HISTORIC AND DESIGN REVIEW COMMISSION

HDRC CASE NO: 2016-365
ADDRESS: 108 N MEDINA
LEGAL DESCRIPTION: NCB 264 BLK 76 N 69.05 FT OF S 133.45 FT OF 9 ARB A9
ZONING: D H HE
CITY COUNCIL DIST.: 5
DISTRICT: Cattleman Square Historic District
LANDMARK: I&GN Depot Cluster
APPLICANT: Michael Mauldin/Mauldin Architects
OWNER: Randall Hoover/North Medina, LLC
TYPE OF WORK: Door fenestration, entry modifications
REQUEST:

Santa Monica Hotel Bldg.
West Elevation Improvements
San Antonio, Tx. 78207

WEST ELEVATION

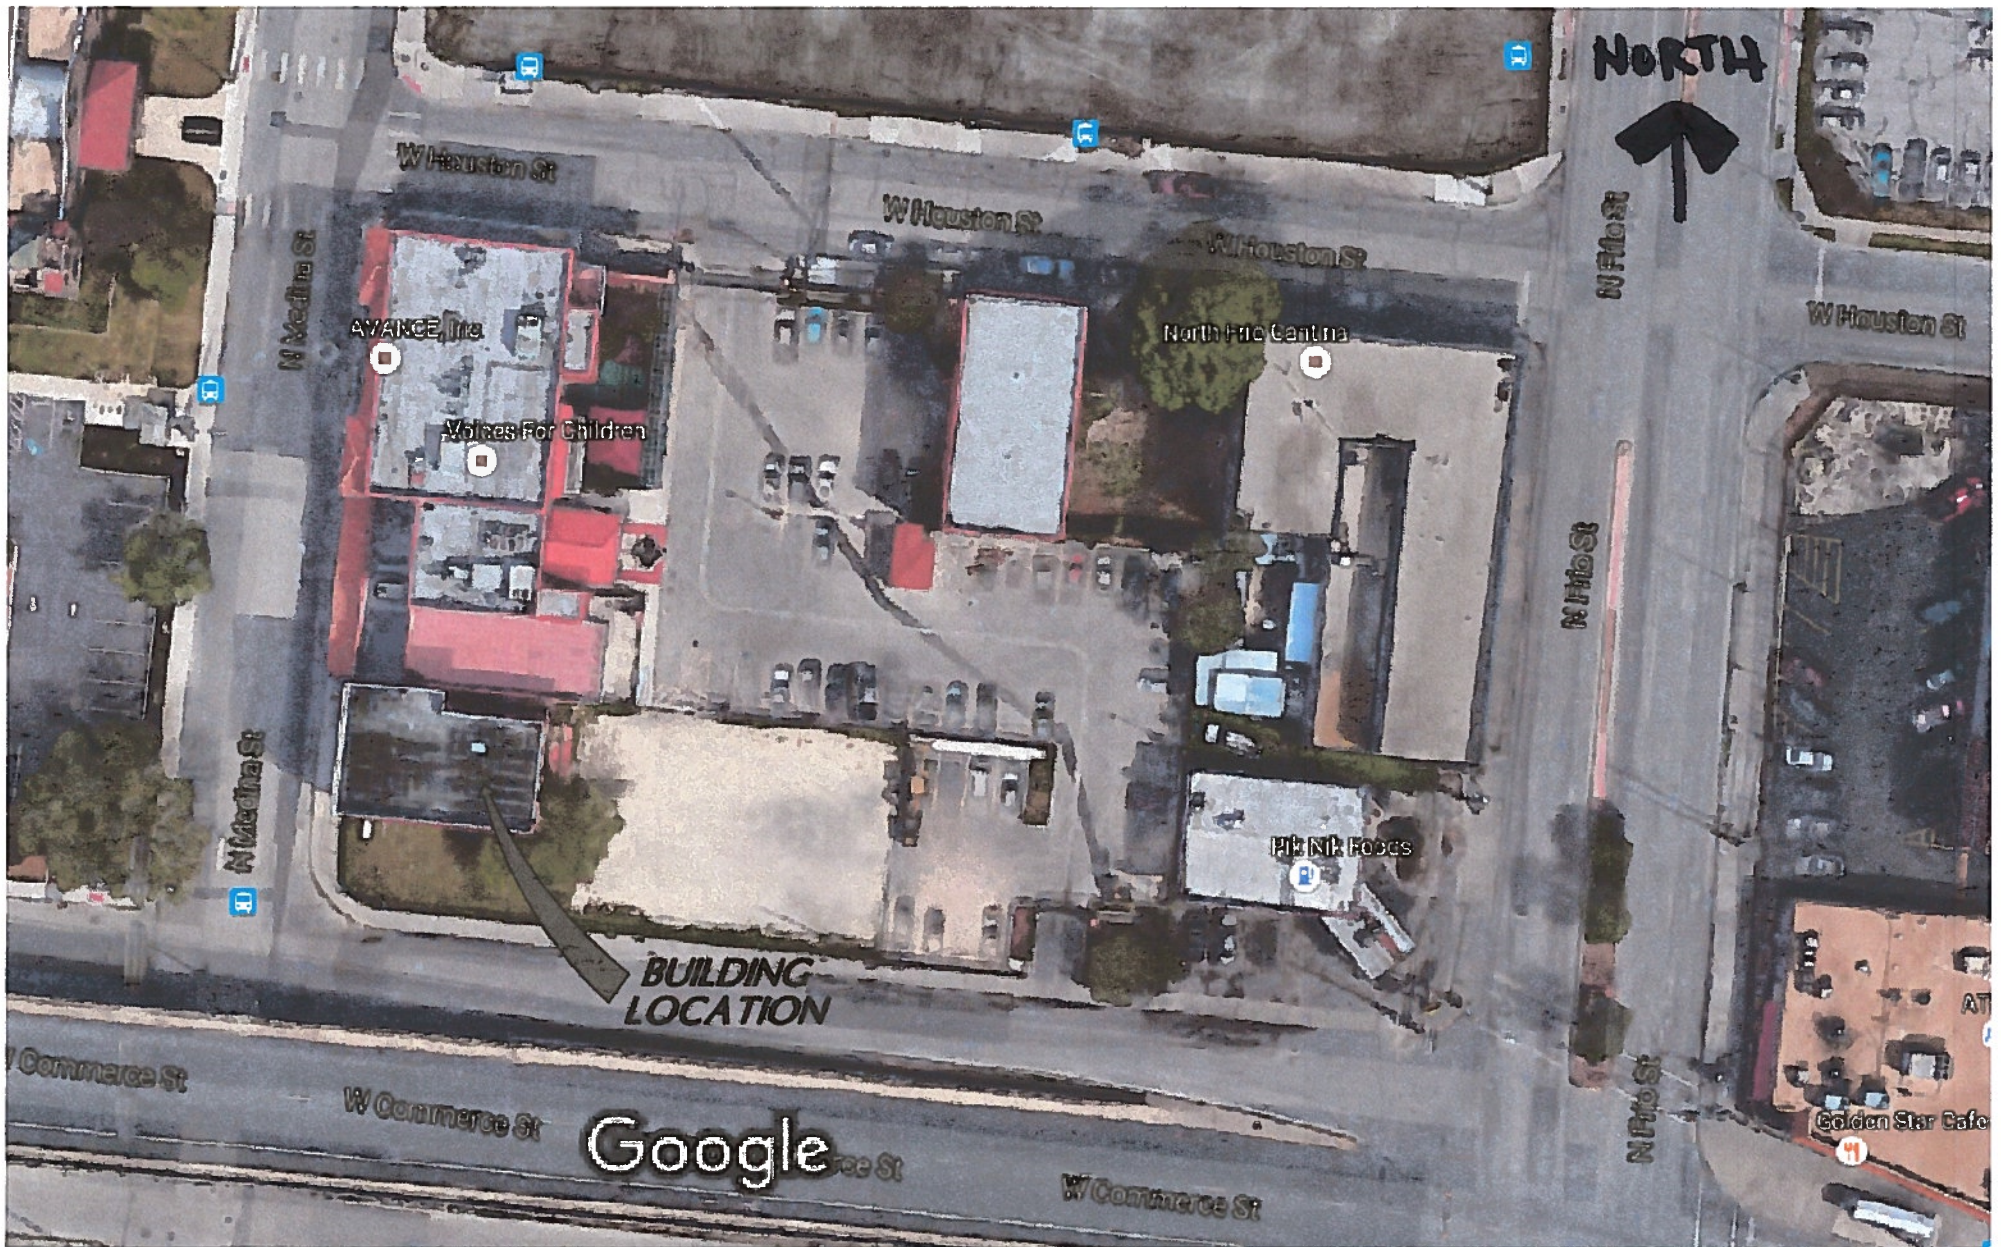
- b. There is an existing non-original wooden door with a wood transom. The applicant is proposing to remove the doors and install a single wood door with panels and single light and two side lights. According to the Guidelines for Exterior Maintenance and Alterations 6.B., non-historic incompatible elements should be replaced with what are typical of the architectural style of the building. Staff finds the proposal to replace the non-original appropriate and consistent with the Guidelines.

- c. There is a door way filled with CMU blocks on the left of the west facade. The applicant is proposing to install a steel door with single light. According to the Guidelines for Exterior Maintenance and Alterations 6.B. and 10.B.ii., non-historic incompatible elements and facades should be replaced with what are typical of the architectural style of the building and based on photographic evidence. Staff finds the proposal appropriate and consistent with the guidelines.

- d. The front window openings currently are filled with CMU blocks and the existing front covered entry is boarded with plywood. The applicant is proposing to remove the plywood and CMU blocks and install fixed windows painted off-white to match those of the neighboring property. According to the Guidelines for Exterior Maintenance and Alterations 6.B. and 10.B.ii., non-historic incompatible elements and facades should be replaced with what are typical of the architectural style of the building and based on photographic evidence. Staff finds that historically these areas would be window openings with glass. Staff finds the proposal consistent with the Guidelines.

1. That the windows be inset one to two inches into the window frame and be made of wood.
2. If the applicant is considering the rehabilitation of the primary historic structure, staff recommends the applicant apply for Historic Tax Certification.
